# ADDENDUM No. 1

## ITB No. 4525

### CREST BUENA VISTA WASHINGTON WATER MAIN PROJECT

STRUCTURE	TYPE	STATION	RIM	DEPTH
V3	12" GWV	6+01	851.51	6.76

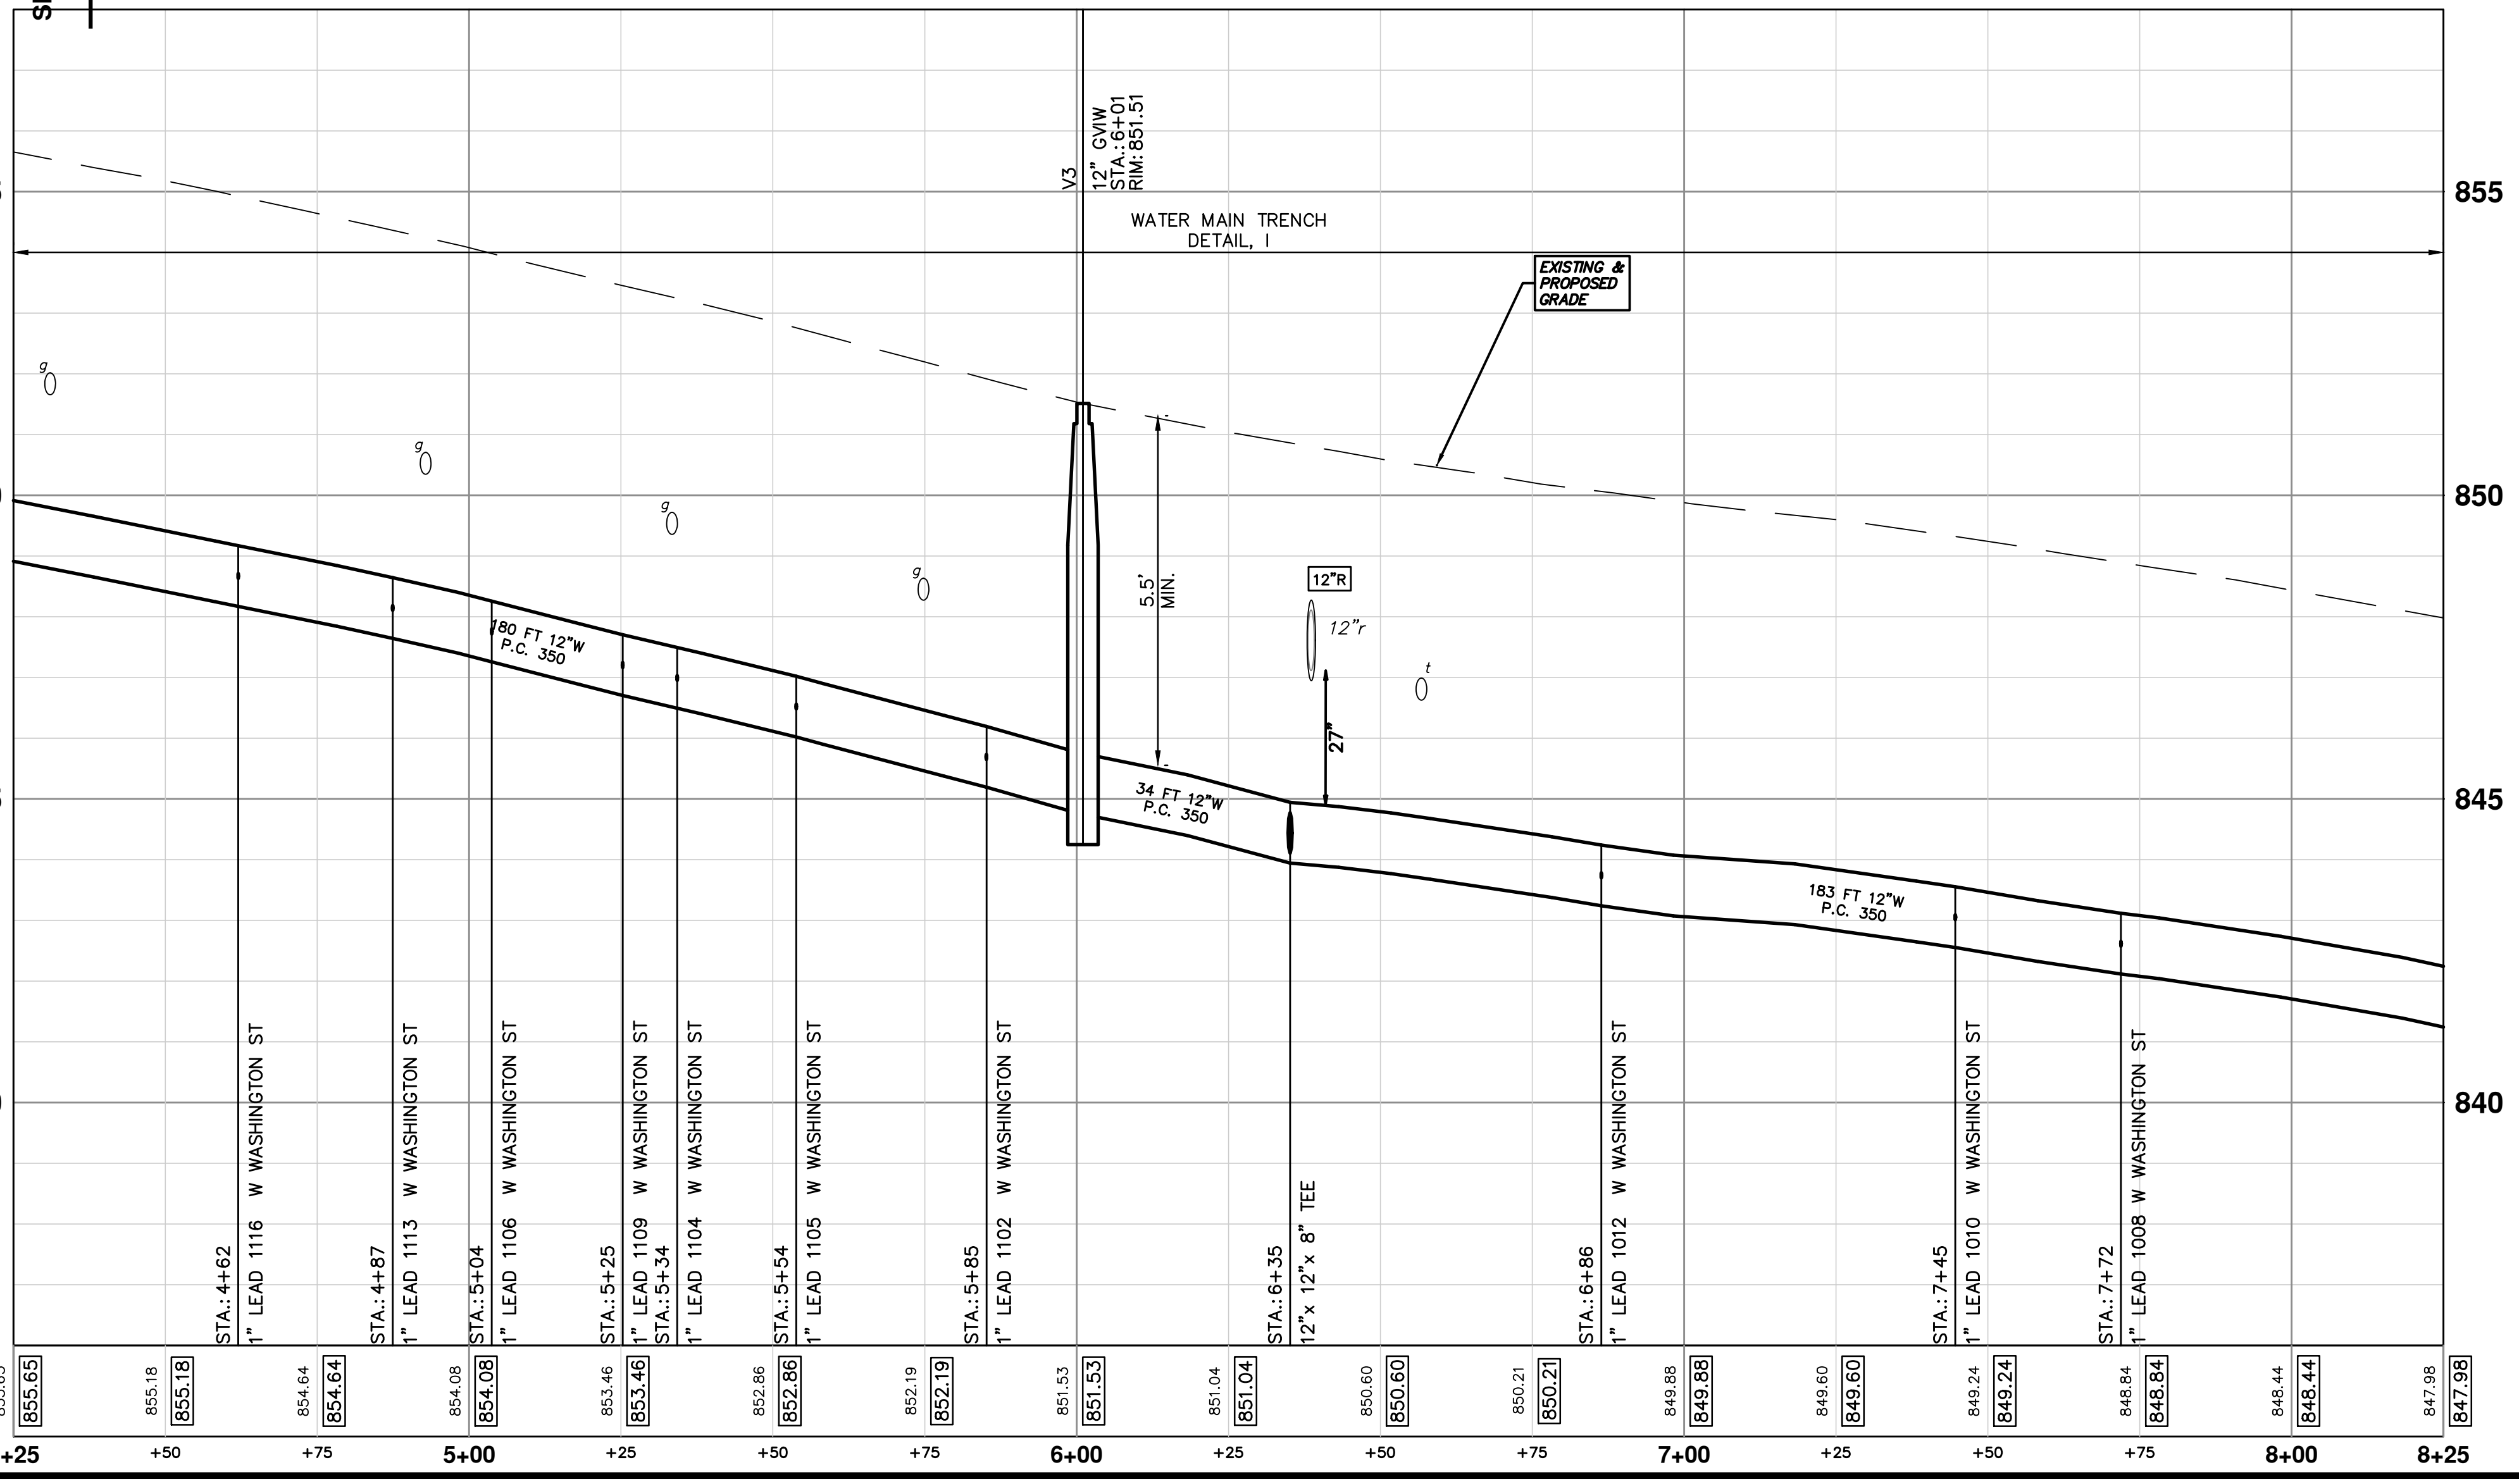
On plan sheet 19, new storm features were added and Water Main Construction Notes.

SHEET NO. 24 OF 46

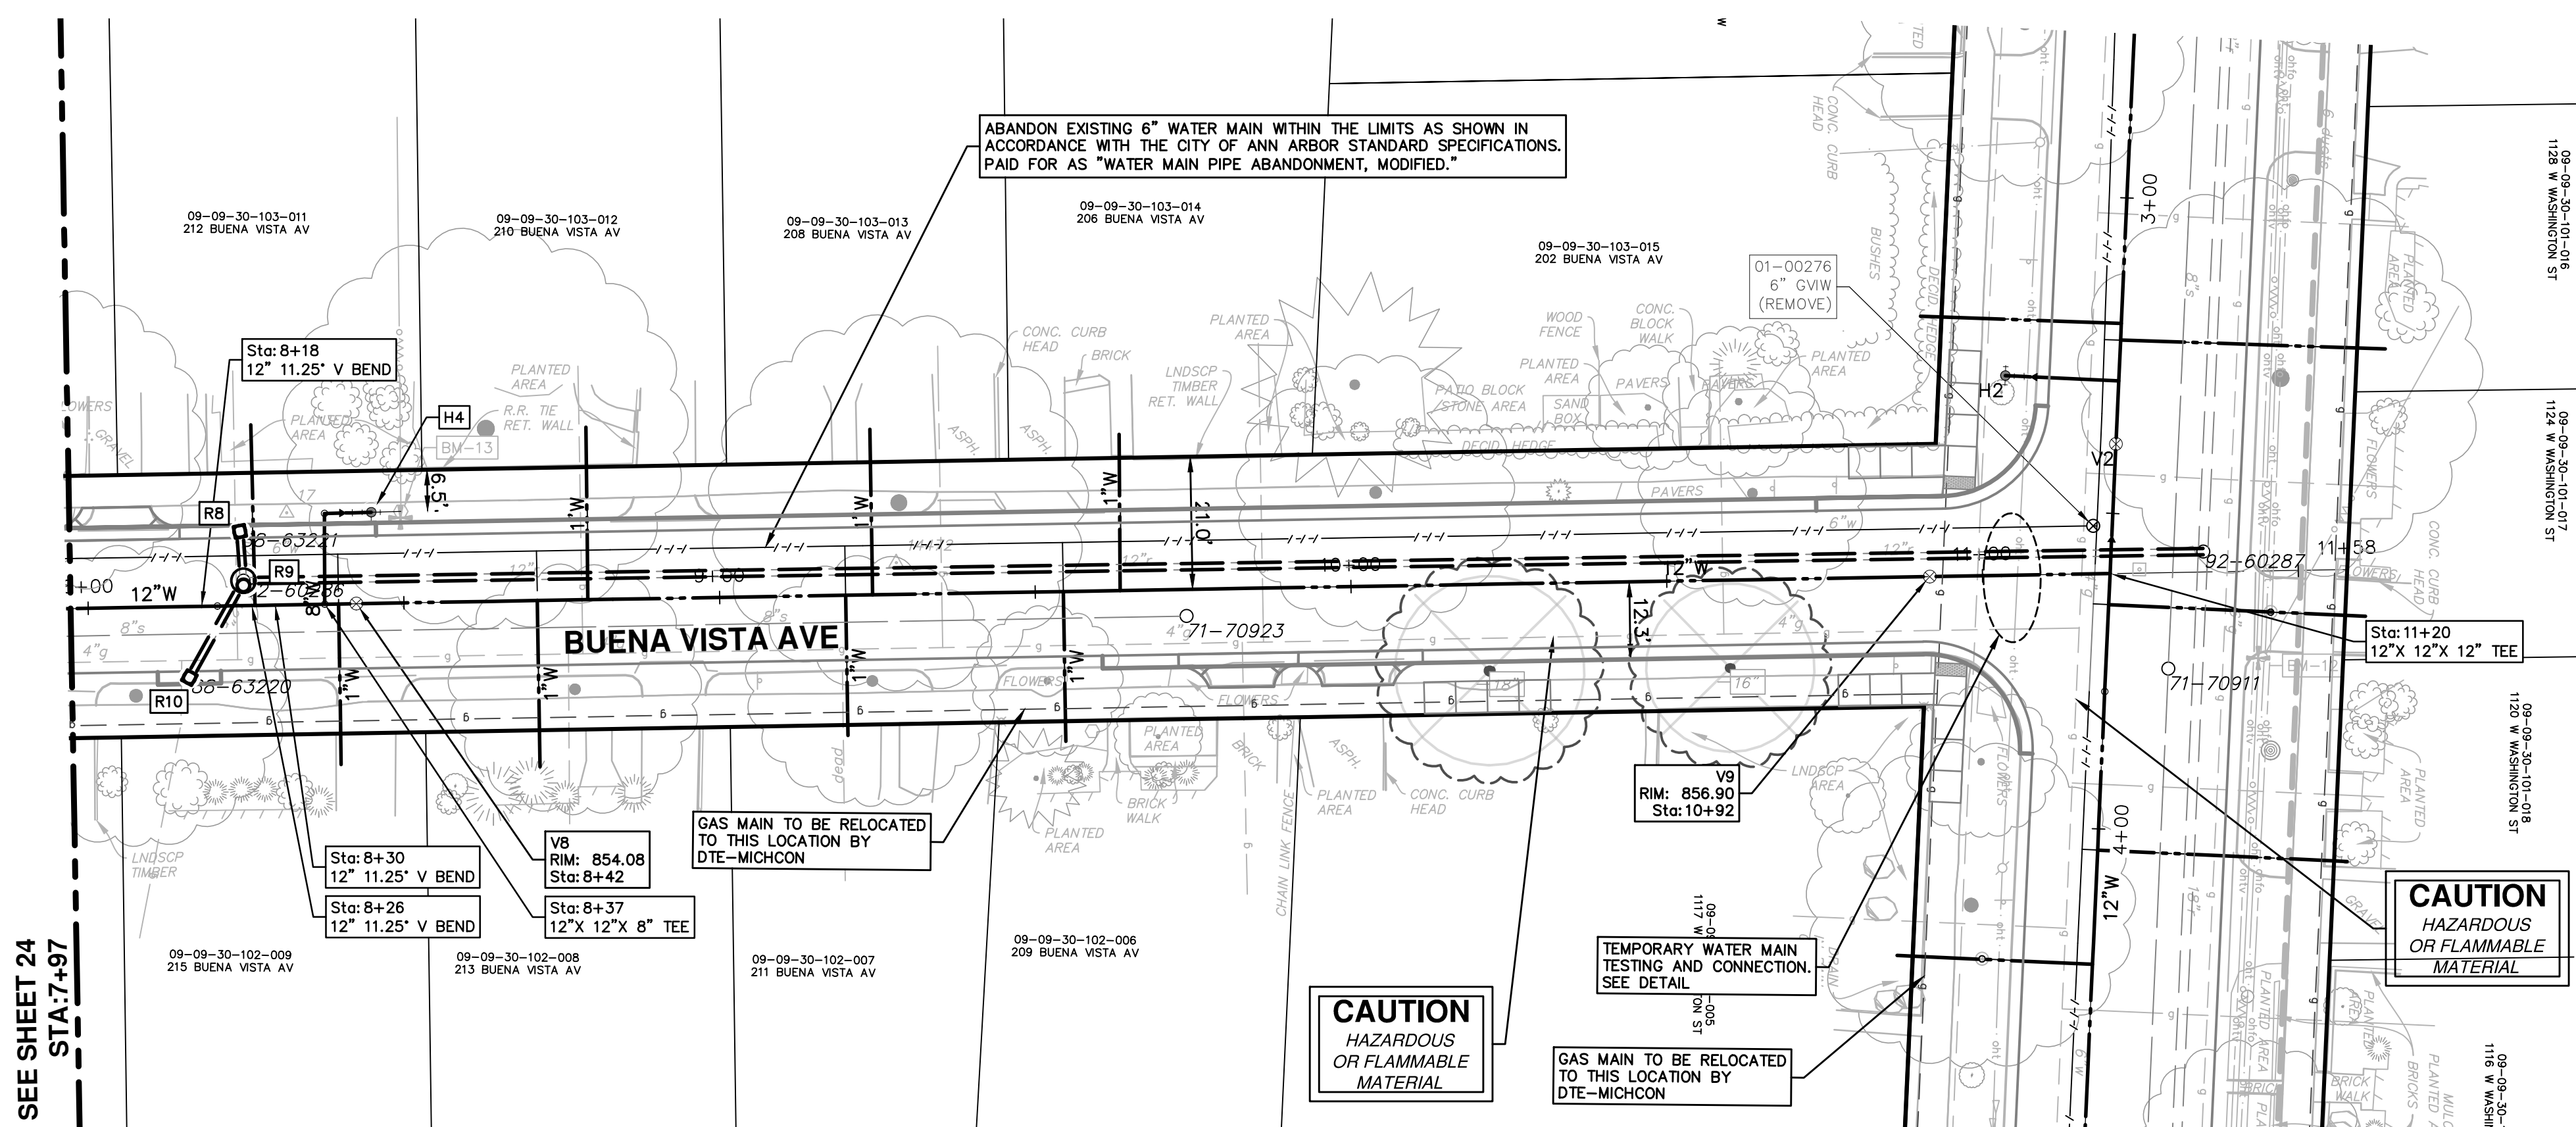
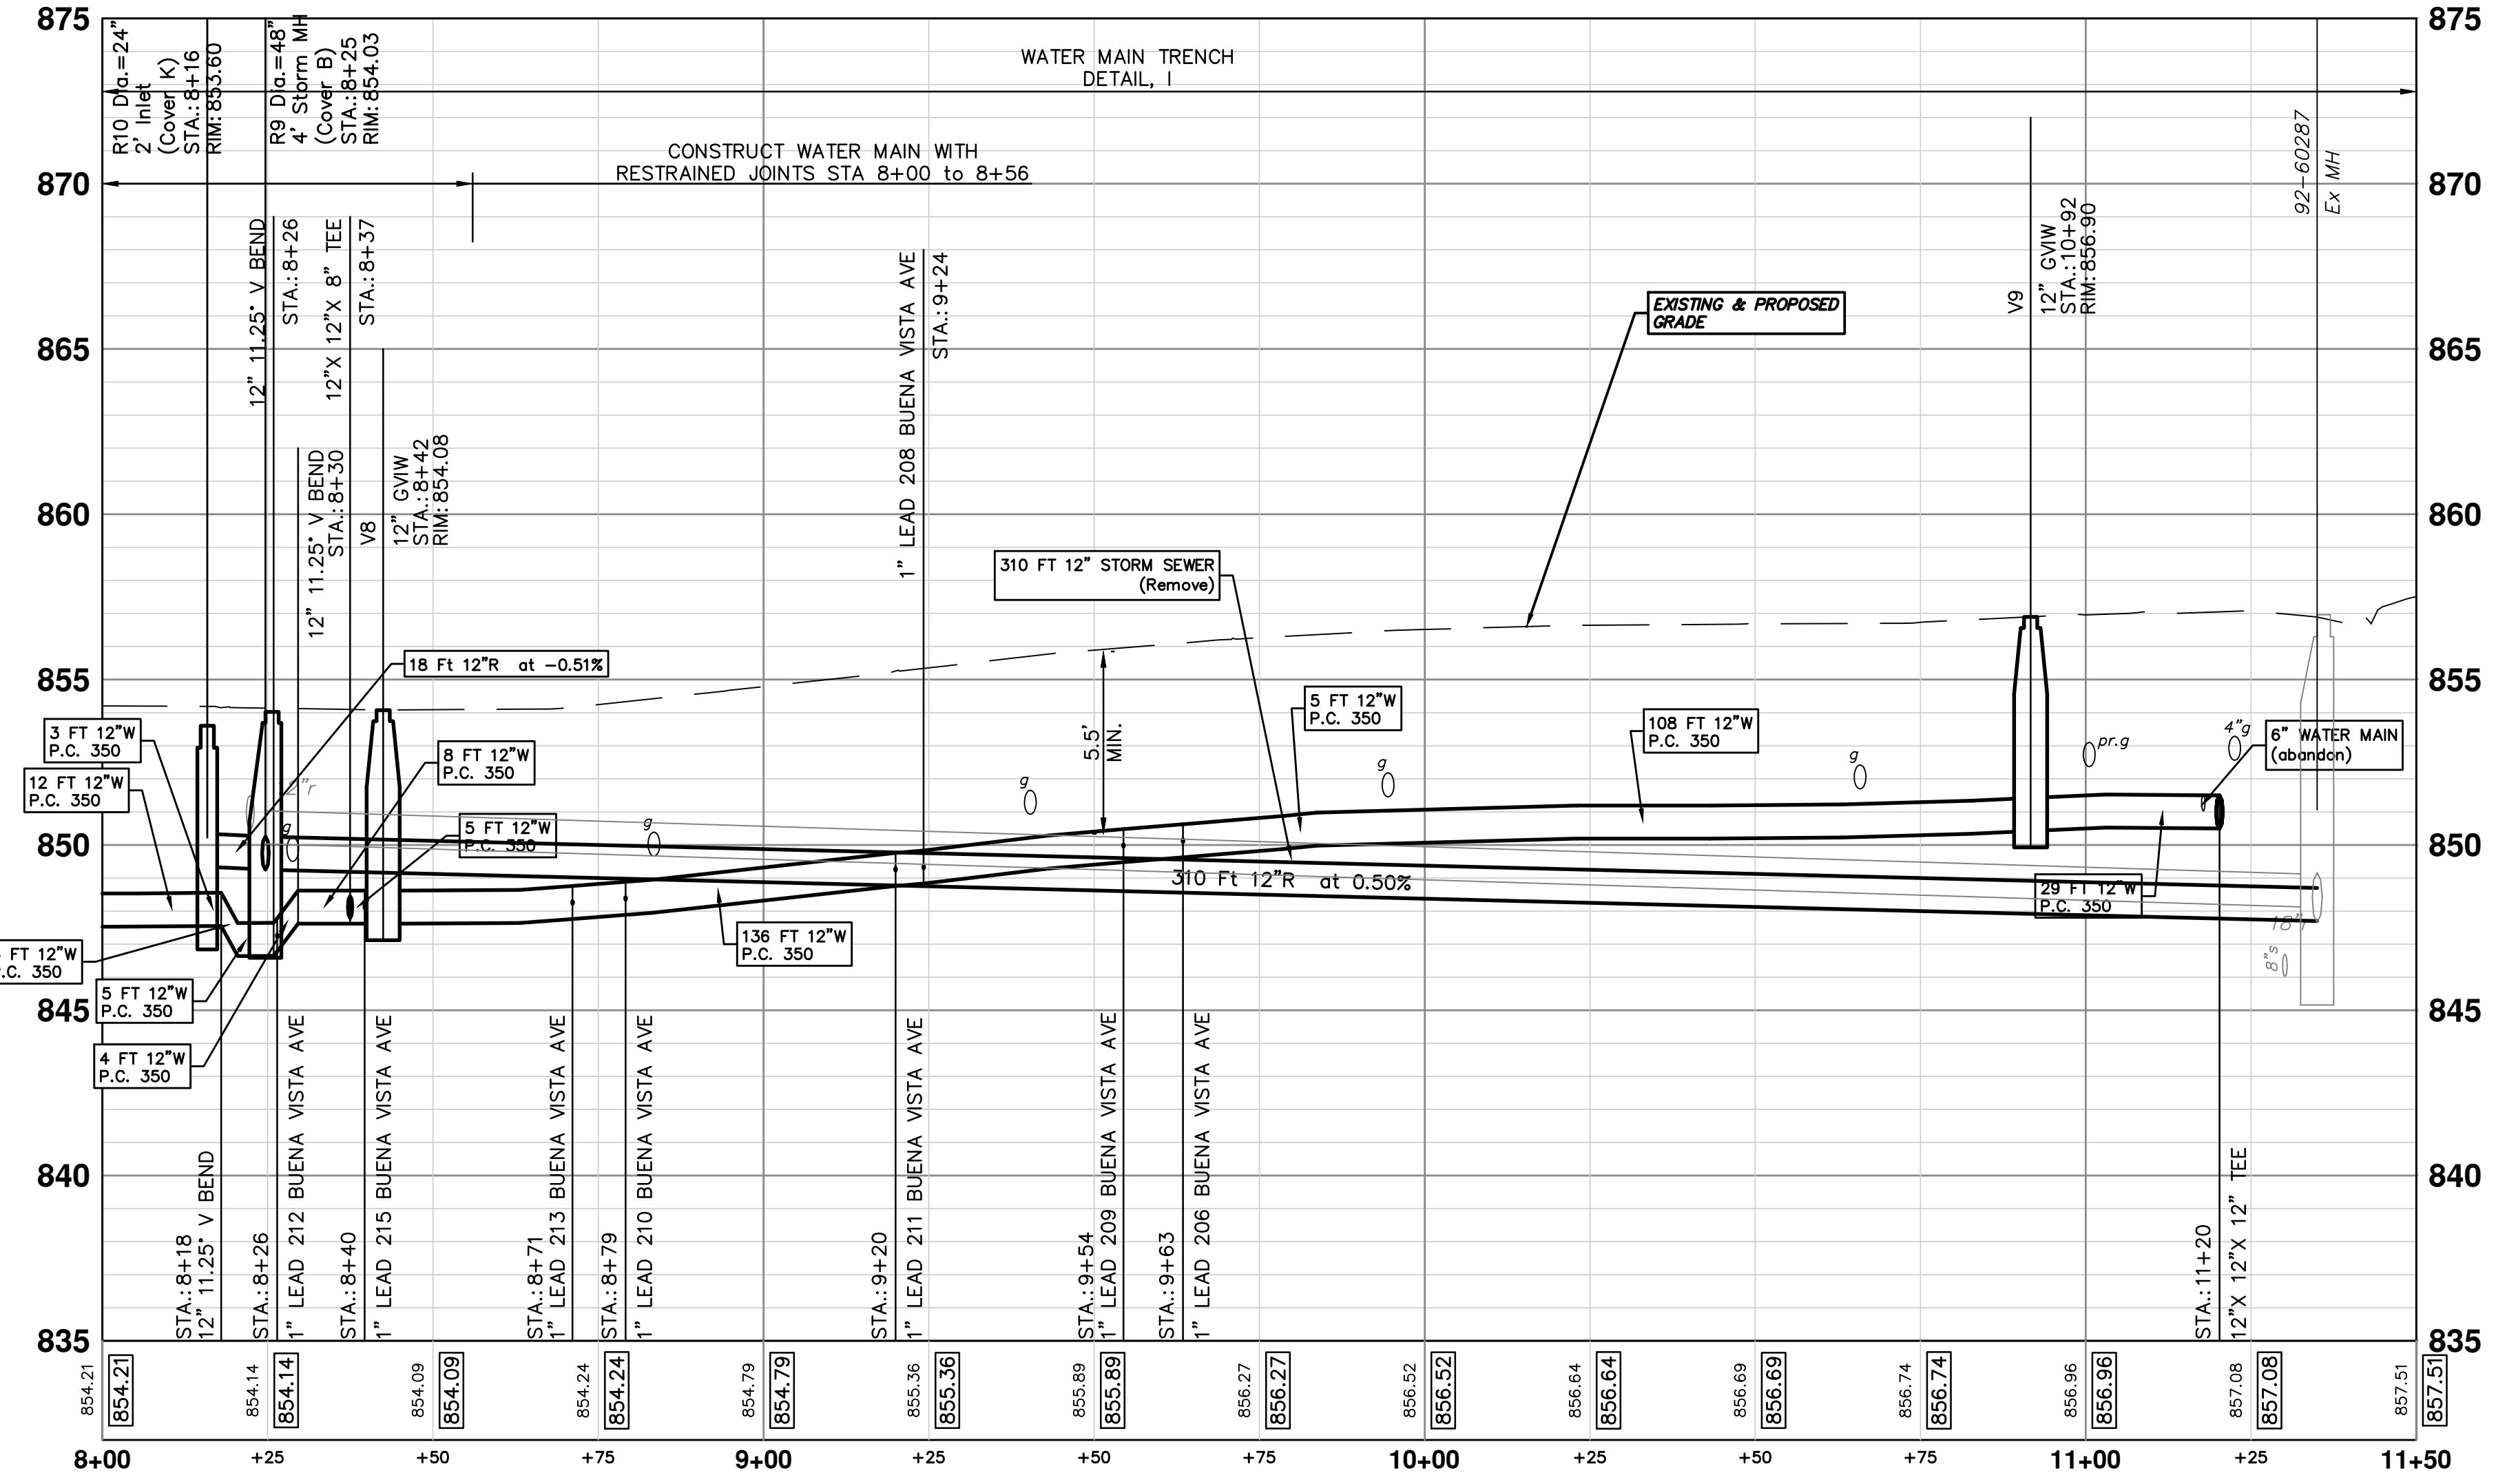
On plan sheet 25, storm features were added and a note about the dead end connection of water at Washington for the Buena Vista Phase I work.
